Memorandum

RE: Other Business for the December 10, 2020 Planning Commission Meeting

This memo is to provide background for the Planning Commission to consider as a part of the Other Business to be reviewed during the December 10, 2020 Planning Commission meeting.

DATE: 30 NOVEMBER 2020 SCALE: PROJECT NO. 12393.CF C3 OF 17

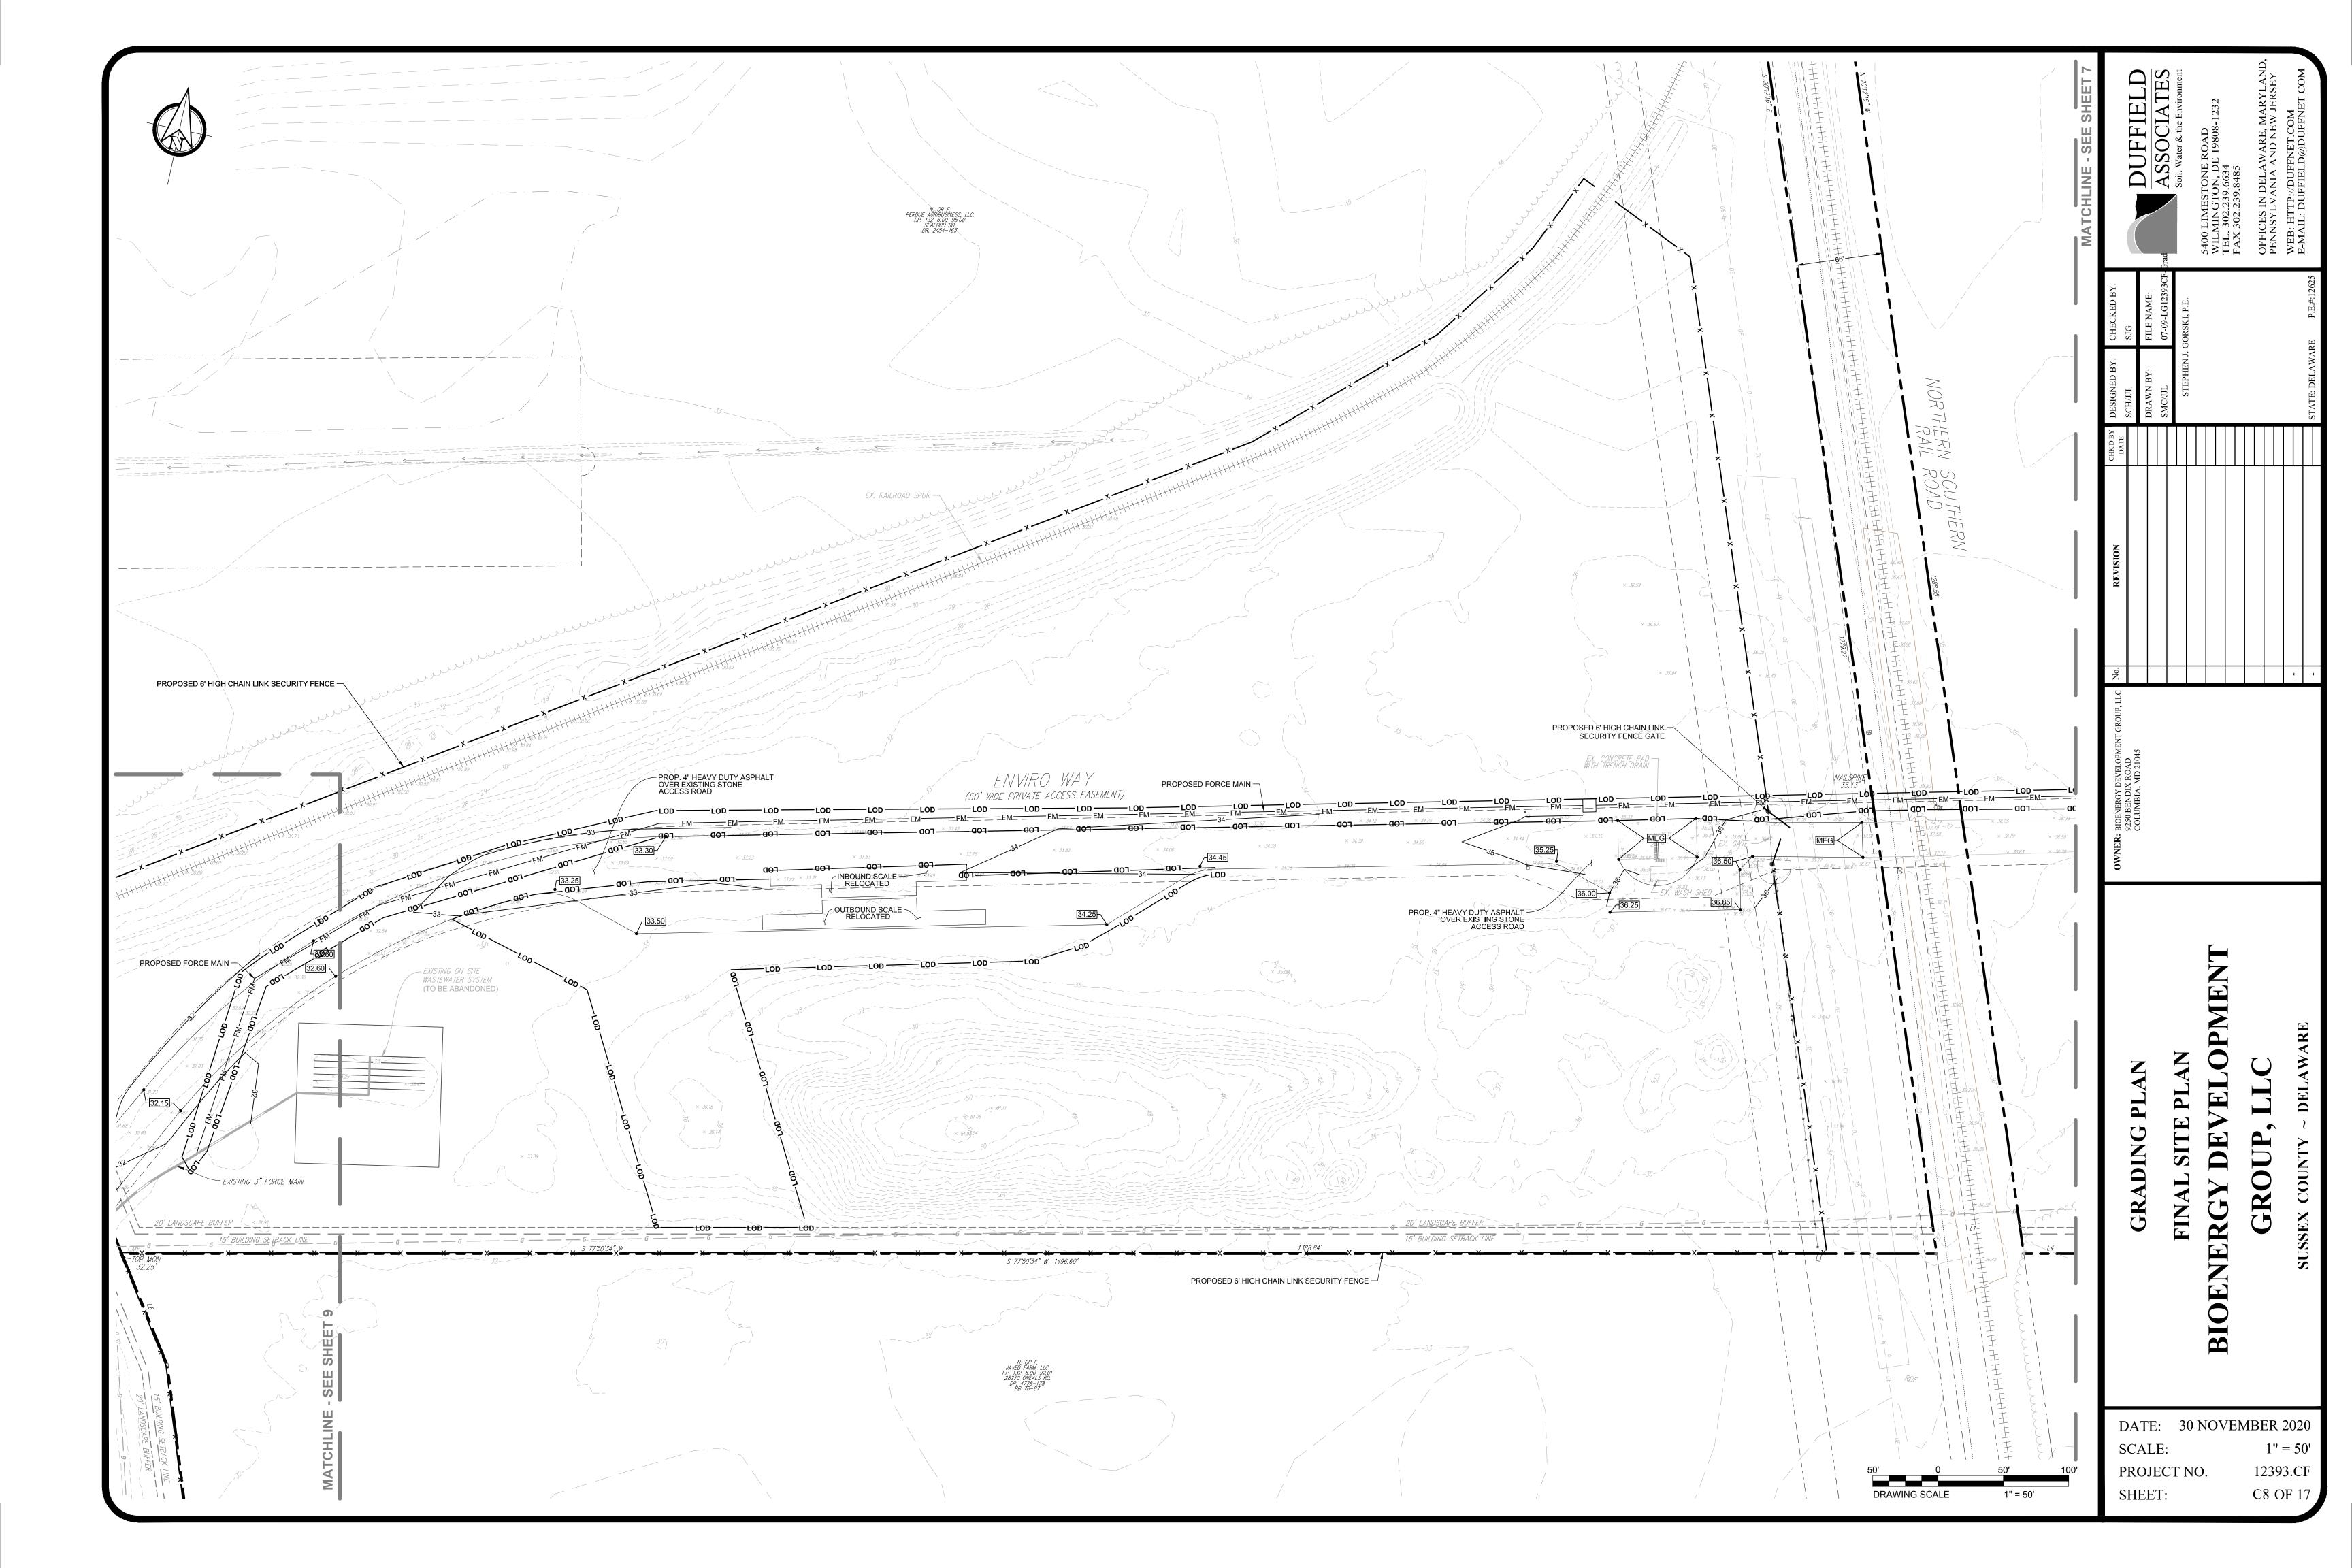
This is a Final Site Plan for the addition of seven (7) storage tanks and other associated works to be located in the already improved area located between Building 1 and Building 3. The site plan also shows a proposed 3,500 square foot maintenance building, along with new landscaping and fencing along Enviro Way. There are no proposed changes to the existing parking numbers and the plans propose the relocation of the scales near the entrance to the site. The parcel is located on Enviro Way, on the west side of Seaford Rd. (Rt. 13A). The use of this site as a composting facility as an addition/extension to the previously approved micro-nutrient plant for the processing and handling of poultry litter was approved by County Council on June 25, 2013 under Conditional Use No. 1962, and this change was adopted through Ordinance No. 2311. The Final Site Plan complies with the Sussex County Zoning Code and all Conditions of Approval. Further Final Site Plan approval will be required for any other future improvements. Tax Parcel: 132-11.00-41.00. Zoning: AR-1 (Agricultural Residential Zoning District). Staff are in receipt of all agency approvals.

The Delaware Department of Transportation (DelDOT) has reviewed your request, dated September 3, 2020, to obtain a Letter of No Contention (LONC) to use an existing commercial building and site entrance for the above referenced project. In coordination with the South District Public Works Office we have determined that your project will require some modifications or enhancements to meet current regulatory requirements. We have therefore determined that this project is eligible to obtain a Permit for Entrance Construction (PEC) to make these modifications. The PEC will include a list of items that must be addressed, as well as requirements for bonding to perform work, where needed, within the State of Delaware right-of-way (ROW). This approval shall be valid for a period of one (1) year.

- 1) Site shall have access from the existing entrance located on Seaford Road (SCR 013).
- 2) Only the modifications/construction or traffic pattern changes that are itemized and authorized under the PEC will be permitted. Please coordinate with the DelDOT Public Works Office regarding the scope, location and limits of the following items, as well any other items listed in the PEC:
 - a) Replace existing stop sign with a new 36"x36" R1-1 stop sign and install a new 16" wide thermo stop bar
- 3) DelDOT reserves the right to review, modify or revoke this authorization letter and PEC and require additional entrance upgrades in the future if proposed activities create traffic conflicts, safety concerns or operational issues.
